Contract No. DOT1209-TRAFFICSIG&ITS  
TRAFFIC SIGNALS & ITS  
Statewide

Enclosed is Addendum No. 3 for the referenced contract consisting of the following:

**CONTRACT DOT1209-TRAFFICSIG&ITS**  
**TRAFFIC SIGNALS & ITS**  
STATEWIDE

**QUESTIONS AND ANSWERS**

SPECIFICATION 746929 746932 746935	CATEGORY CODE ITEMS SIGNAL HEADS	<b>DELAWARE DEPARTMENT OF TRANSPORTATION</b> TRAFFIC CONSTRUCTION DETAILS SIDE POLE MOUNTING FOR VEHICULAR AND PEDESTRIAN SIGNAL HEADS
APPROVED _____ CHIEF TRAFFIC ENGINEER		
DETAIL NO.		DE 746.006-01

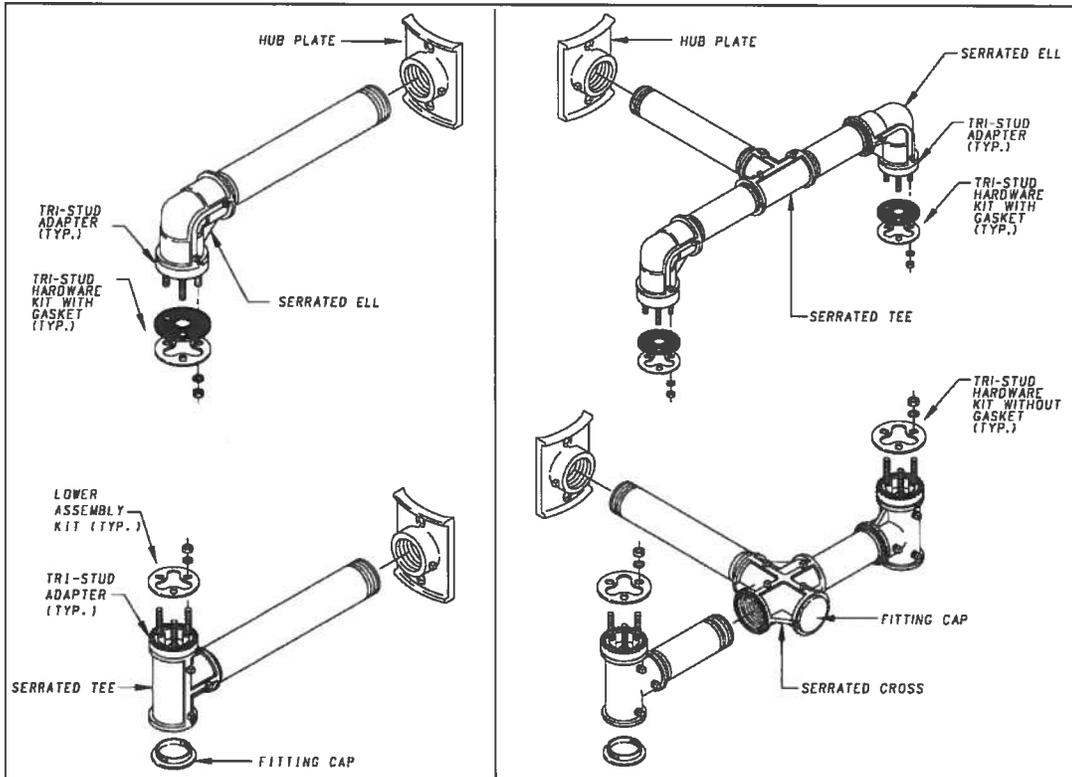
3 Revised Notes (5/18/12)

3. THE UPPER ARM SHALL CONSIST OF A SERRATED ELL, 12" NIPPLE, GASKET AND TRI-STUD ADAPTER.
  - THE SERRATED ELL SHALL HAVE A SERRATED 72 TOOTH BOSS ON ONE END WITH TRI-STUD MOUNTING. THE OUTSIDE DIAMETER OF THE SERRATION SHALL NOT EXCEED 2 3/8". THE NON-SERRATED END OF THE ELL SHALL BE NOTCHED TO ACCEPT A SEPARATE SERRATED LOCKRING. THE ELL SHALL BE THREADED 1 1/2" NPS ON BOTH ENDS. THE ELL SHALL HAVE A MINIMUM 3/8" WIDTH BOSS THAT EXTENDS THE ENTIRE LENGTH OF BOTH SIDES, ON ONE SIDE OF THE BOSS AT EACH END OF THE ELL SHALL BE A 1/4" - 20 THREADED OPENING FOR A SETSCREW.

- A 1 1/2" X 12" EXTRUDED NIPPLE SHALL HAVE 1 1/2" NPS THREADS ON BOTH ENDS. THE NIPPLE SHALL HAVE A "BRUSHED" FINISH.
4. THE LOWER ARM SHALL CONSIST OF A SERRATED TEE, 12" NIPPLE AND TRI-STUD ADAPTER.

- THE SERRATED TEE SHALL BE FABRICATED LIKE THE ELL EXCEPT THE TEE IS TO HAVE SERRATIONS ON TWO (2) THREADED OPENINGS 90° APART. THE NON-SERRATED END SHALL COME STANDARD WITH A PLASTIC KNOCKOUT PIN.

- THE 1 1/2" X 12" NIPPLE SHALL BE THE SAME AS ABOVE.
5. FOR WOOD POLE MOUNTING:
  - ATTACHMENT STRAPS FOR WOOD POLE SHALL BE 3/8" WIDTH, TYPE 201, STAINLESS STEEL.
